Subject: **Soil, Groundwater, and Soil Gas Workplan Addendum**
3101 35th Avenue, Oakland, CA
Fuel Leak Case No. RO0003164; Global ID T10000006539

Subject: Soil, Groundwater, and Soil Gas Investigation Work Plan Addendum
Green Oak Builders – RO0003164
3101 35th Avenue, Oakland, California

DETAILED SITE MAP SHOWING UPDATED
PROPOSED BORING LOCATIONS

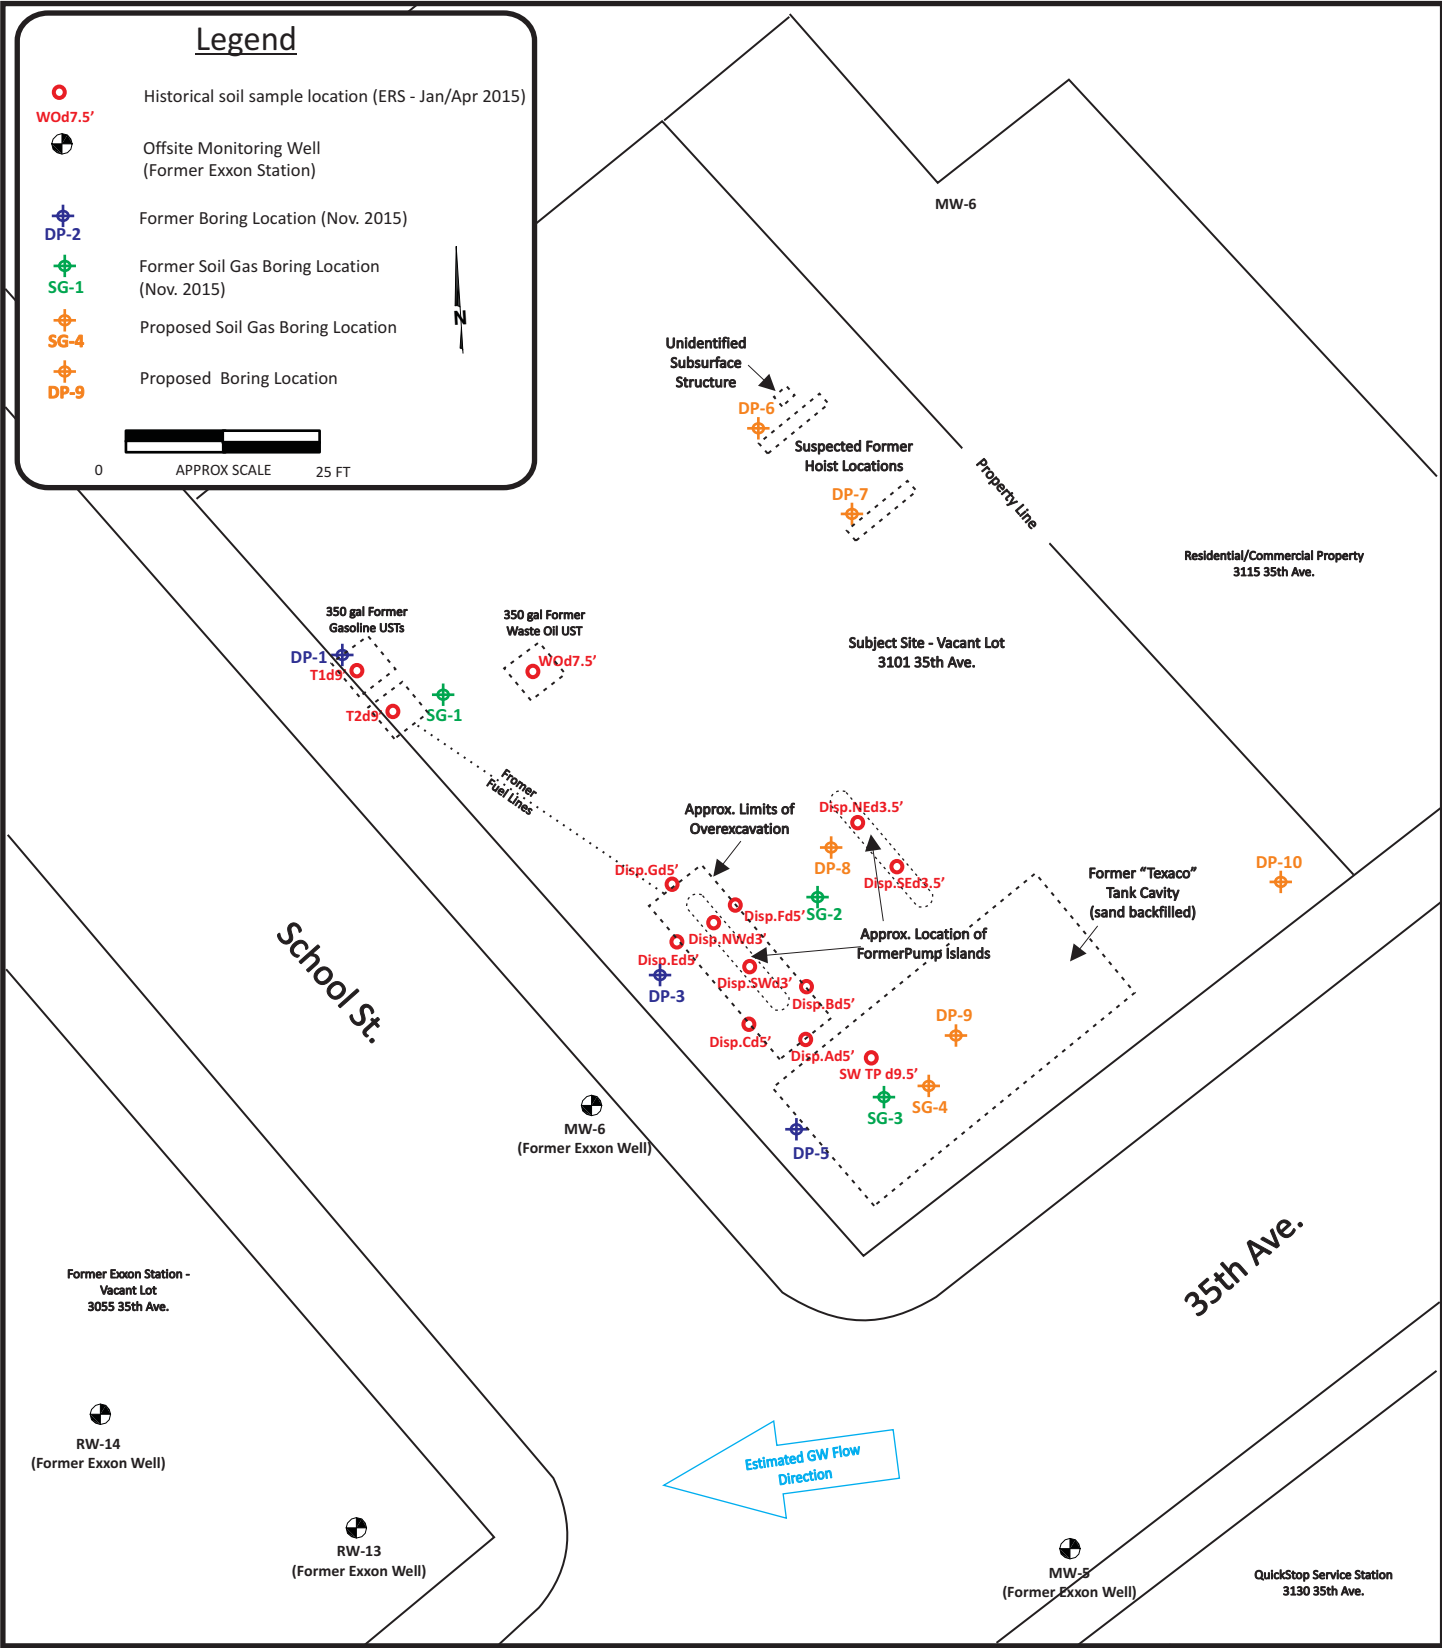
1. **Additional Soil Bores** – ACEH was provided a figure, captioned *Figure 5*, as an attachment to an electronic mail dated October 2, 2015. *Figure 5* was prepared by Almar and provided additional locations for soil bores which were to be investigated in a work plan approved by ACEH in its letter of the same date. These locations have not been investigated. ACEH requests that the soil bores identified as DP-6 and DP-7 on the October 2, 2015 *Figure 5* be incorporated in to the work plan addendum in lieu of the DP-6 proposed in the Work Plan.

- The requested additional boring location has been added to the proposed scope of work. To avoid confusion, the name of previously proposed boring DP-7 has been changed to DP-10. The new boring locations and names are shown on the attached *Figure 1*.
